STAFF REPORT

ITEM: Wyndham Village Preliminary Plat and Zoning Map Amendment

Re: Wyndham Village Preliminary Plan Review

Job No. 2016-70
SHEET 2 OF 2

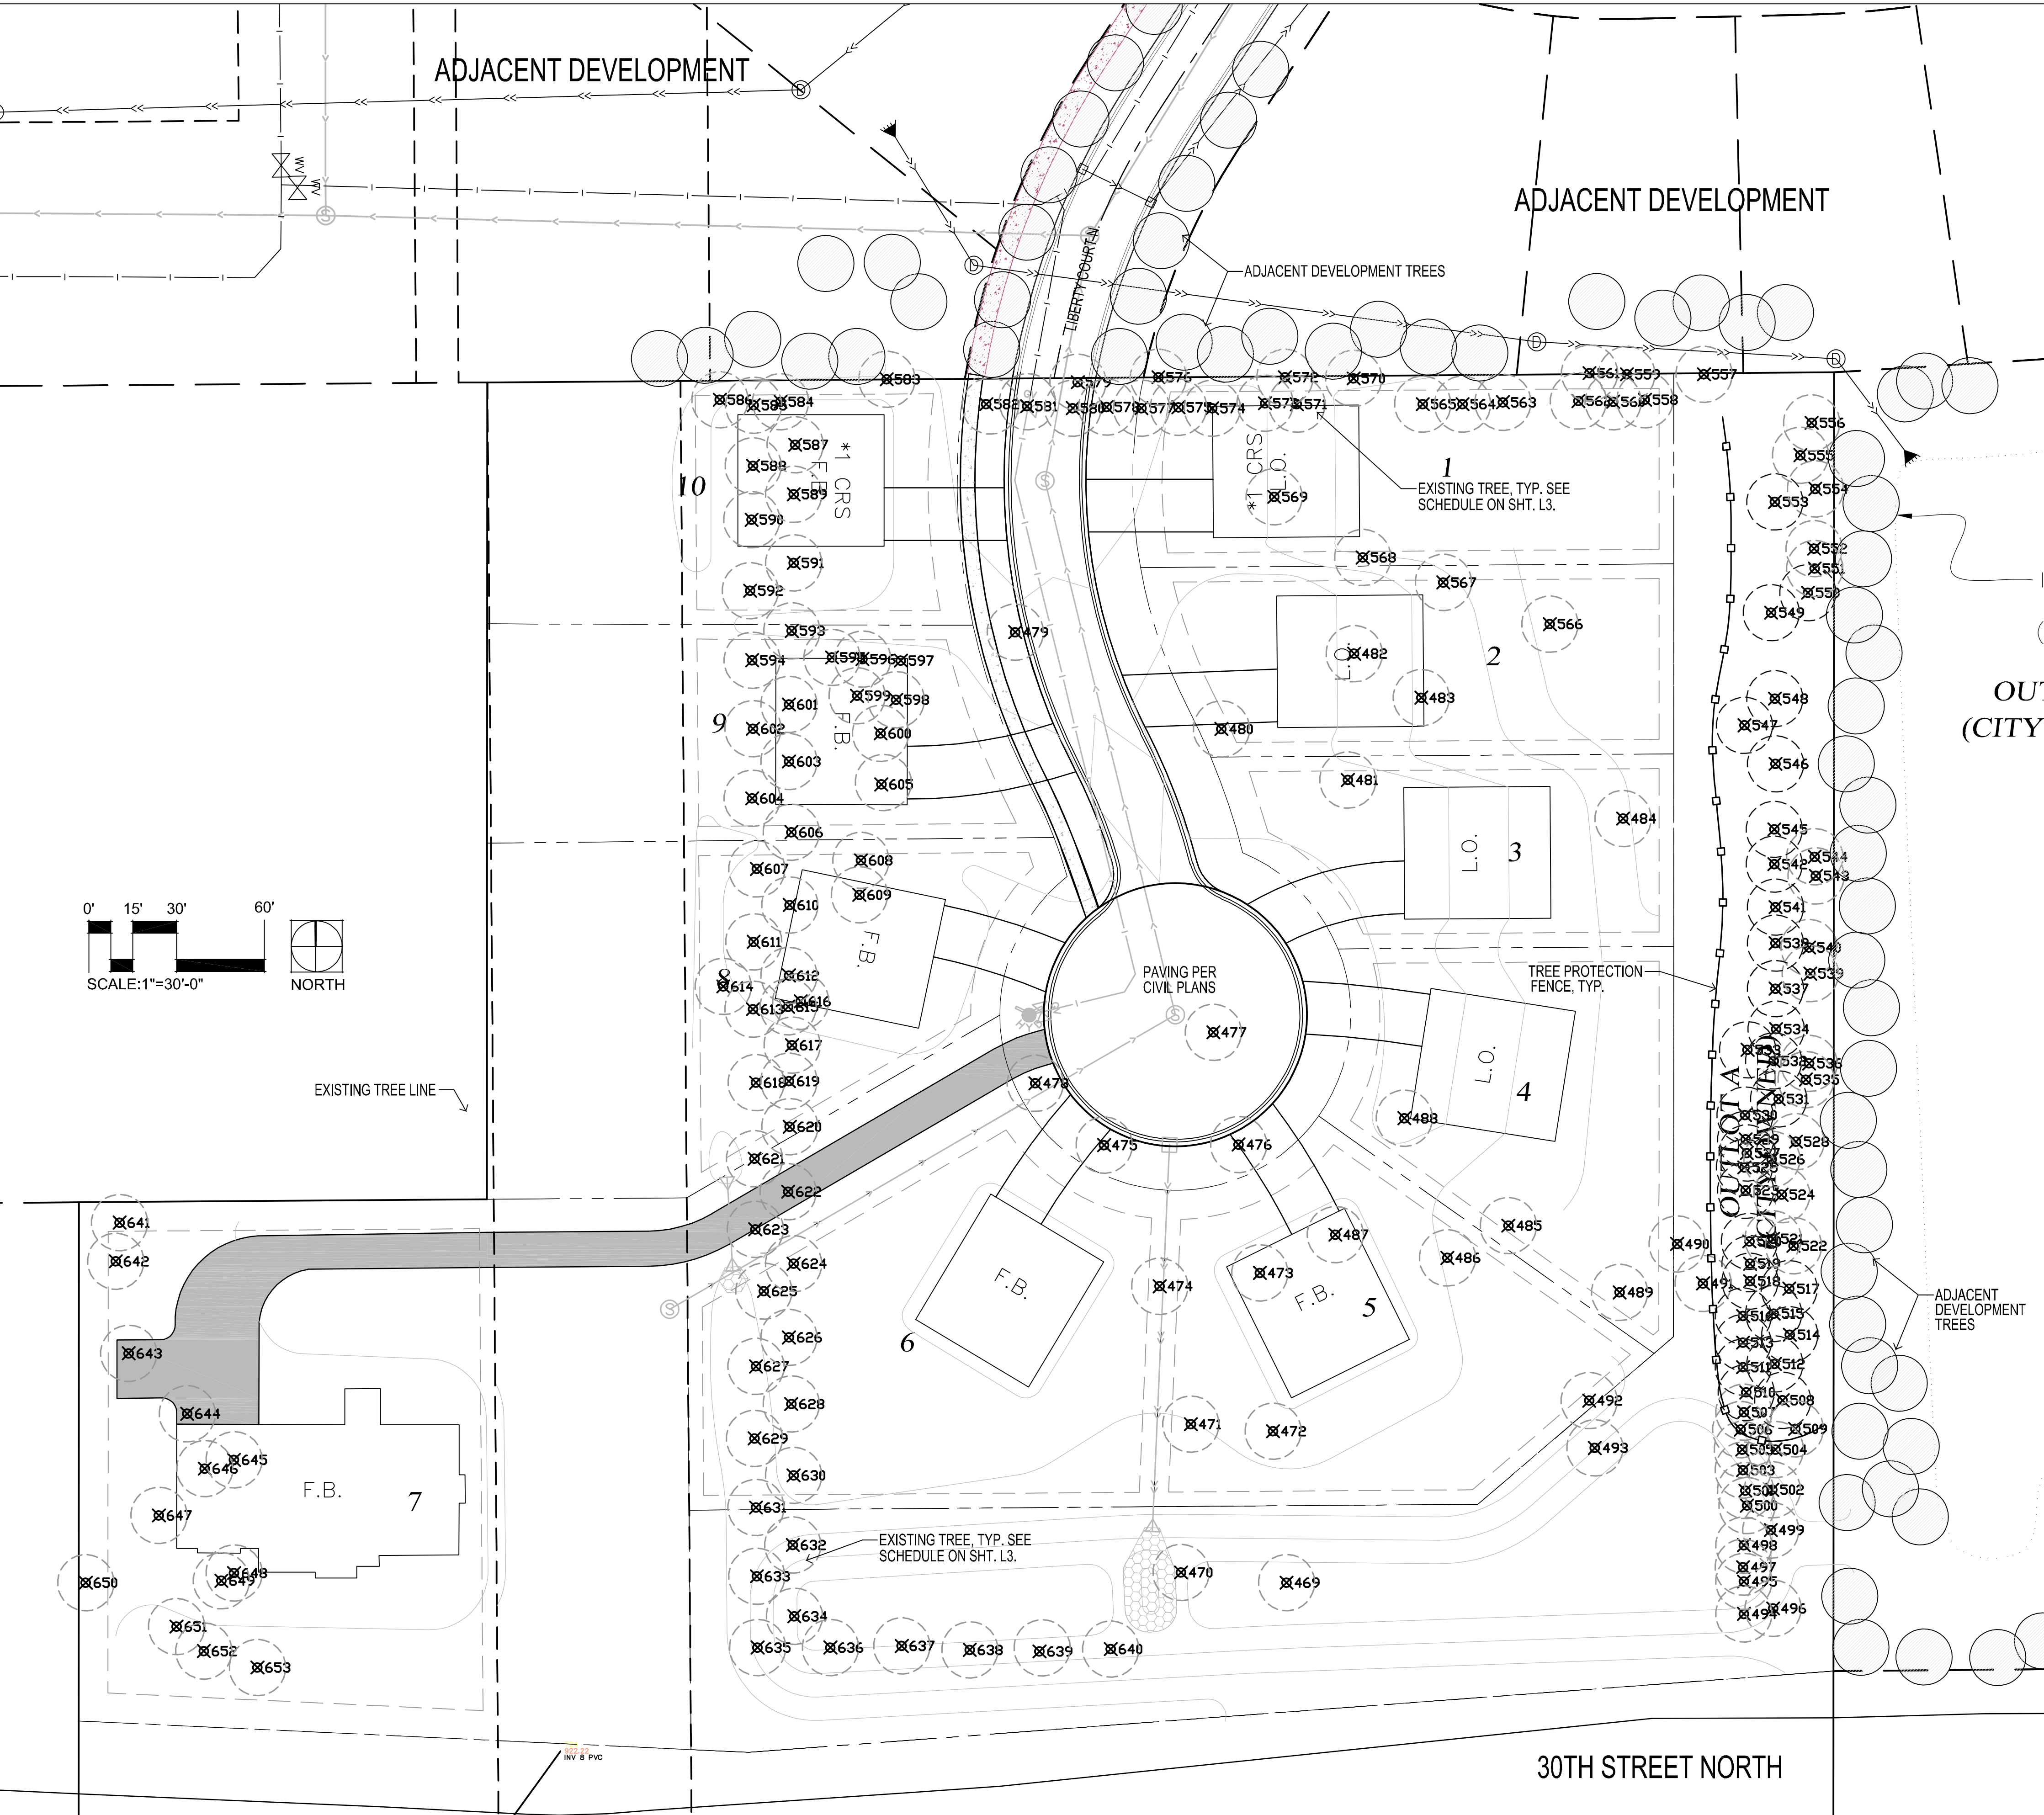
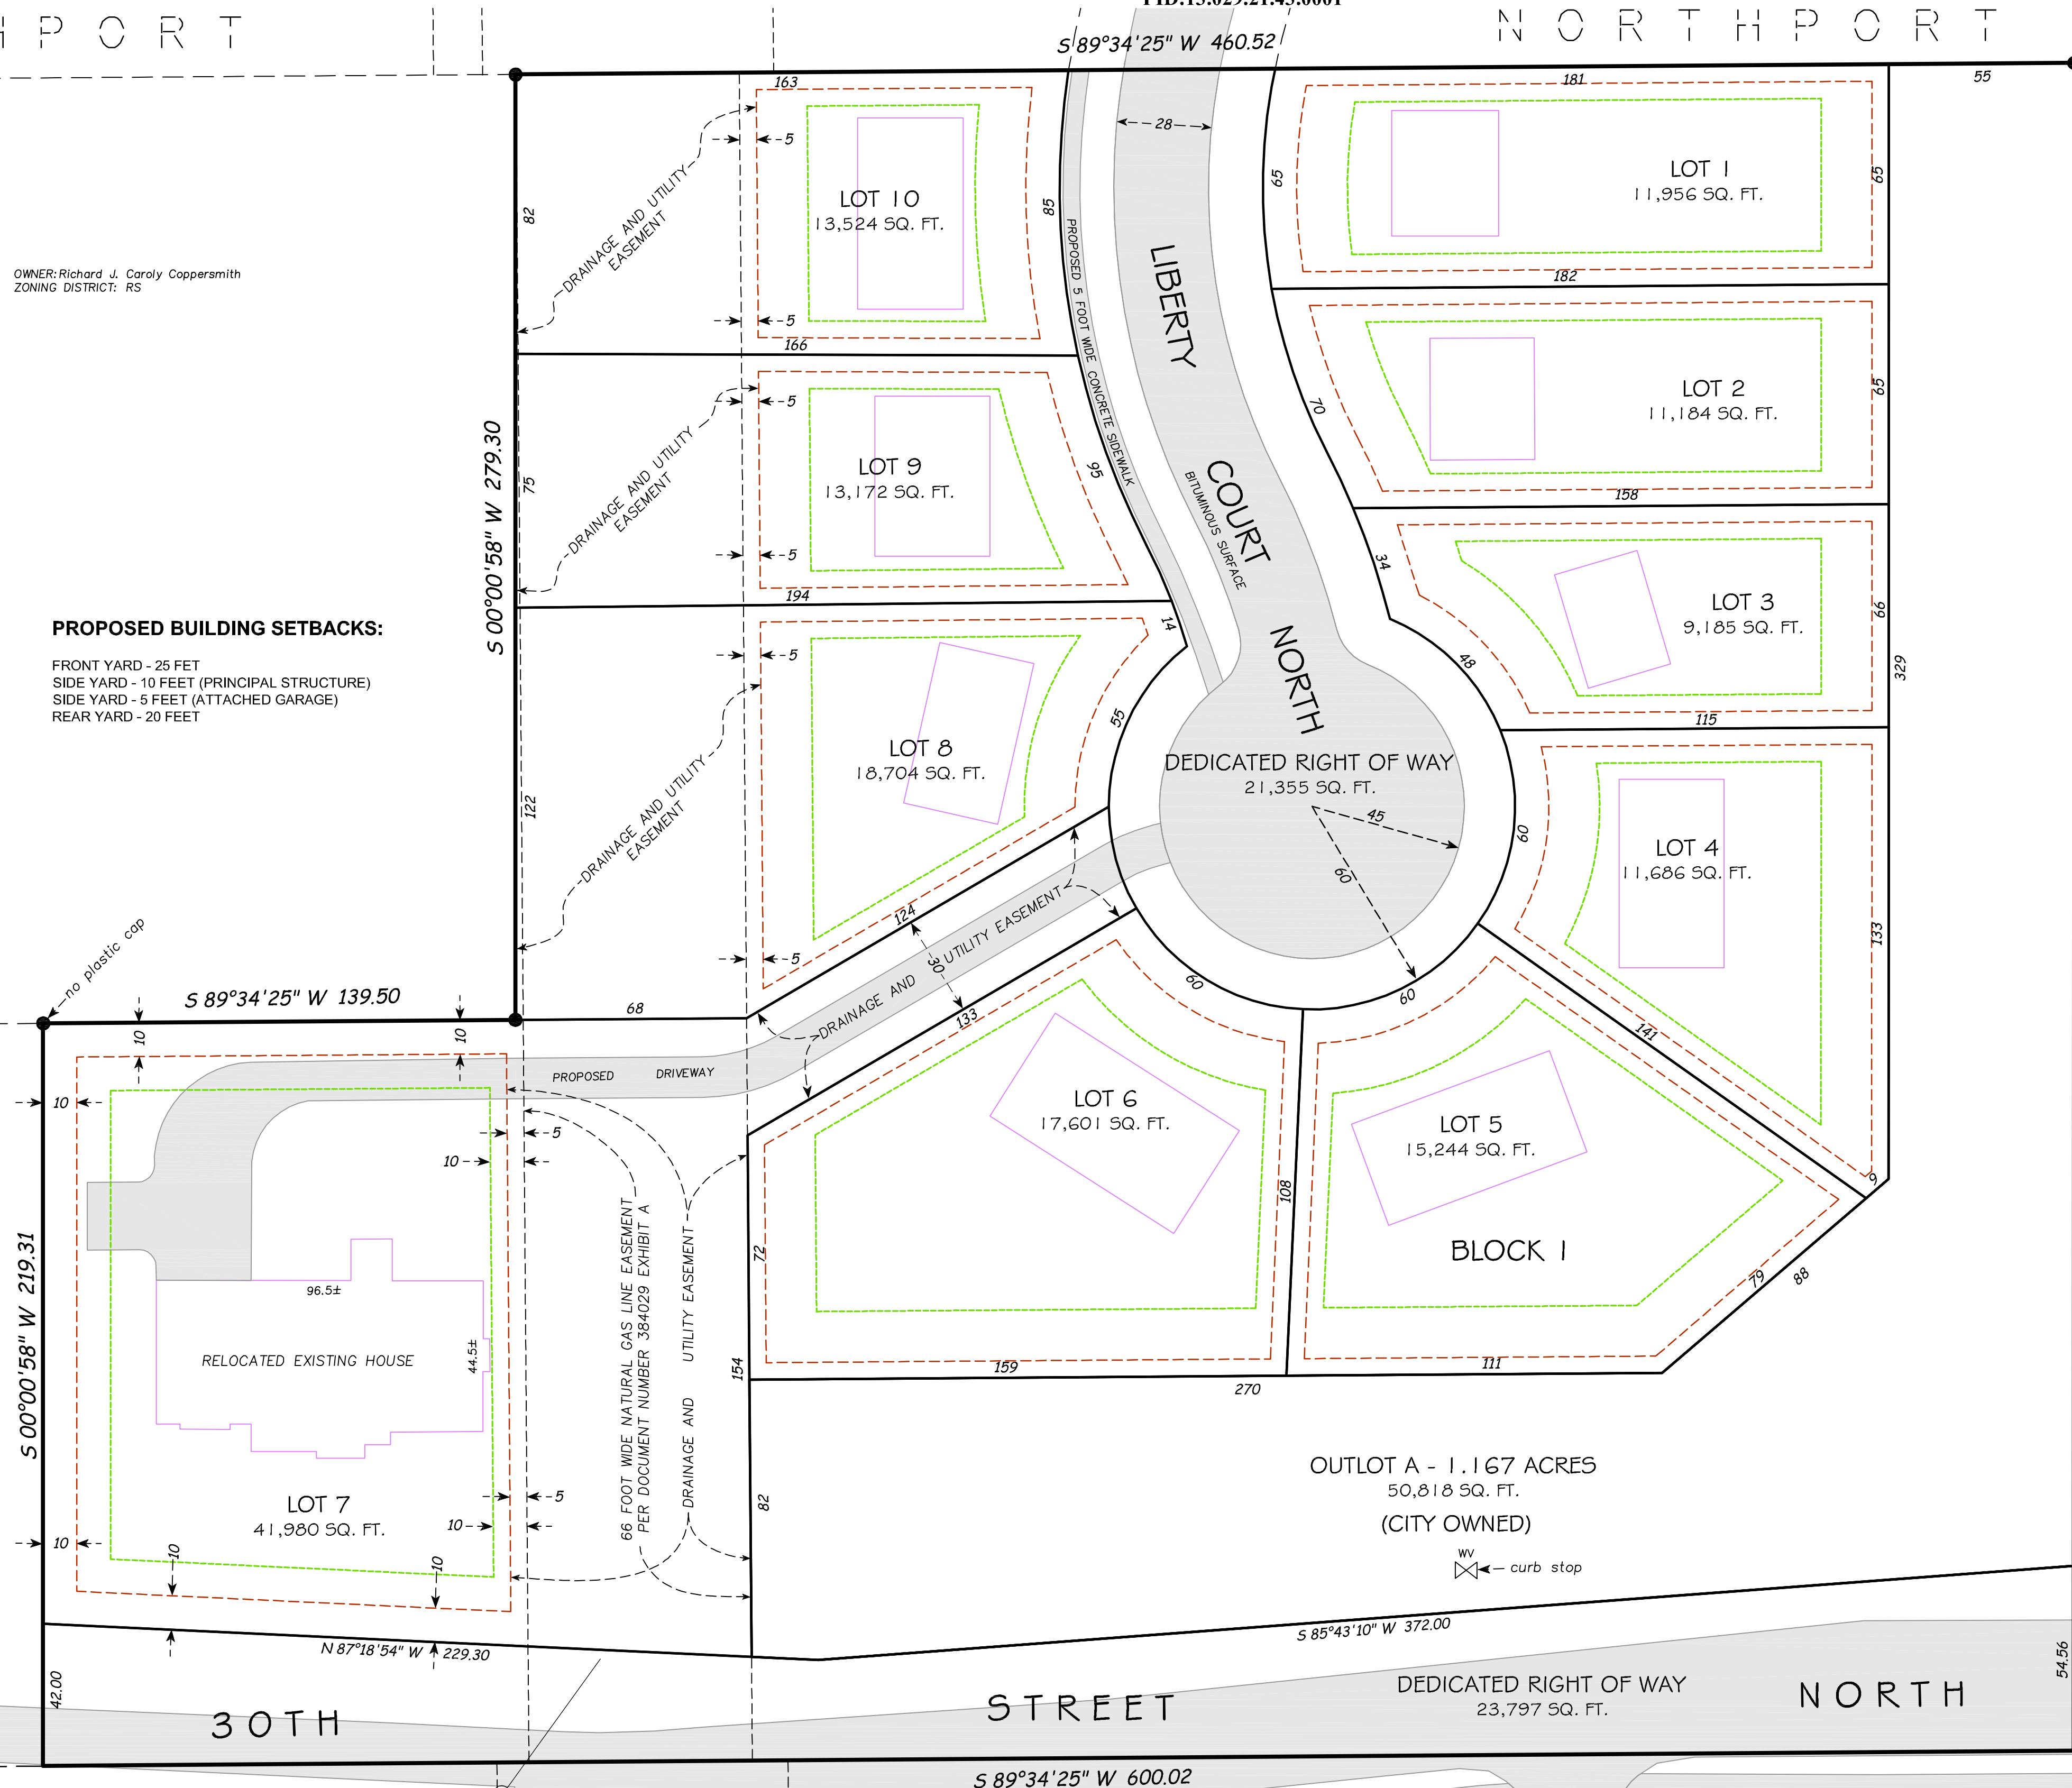
- Right-of-way/Easement Dedication. The Preliminary Plat and all preliminary plan sheets must be revised to dedicate additional right-of-way along 30th Street North to ensure a minimum 30th Street boulevard of 16 ft. along the entire length of the plat. The current plans show a varied boulevard width from 11-25 feet. In addition, a 10 ft. utility corridor must be reserved (at boulevard grades) for small utilities. The proposed storm water facilities (including the 100-year HWL) must be revised further north to prevent encroachment onto the 10 ft. utility corridor.

- Outlot A must be dedicated to the City for storm water maintenance. Outlot A has been shown as City-owned on the preliminary plat and plans as required. Outlot A may need to be revised to accommodate additional right-of-way along 30th Street and/or to expand the storm water 100-year HWL flood area.

- Drainage and utility easements are required over all storm sewer, sanitary sewer and watermain not located on City Outlots and right-of-way, minimum 30-feet in width centered on the pipe/structure. Easements must be shown on the Preliminary Plat, Utility Plans and Grading Plans.
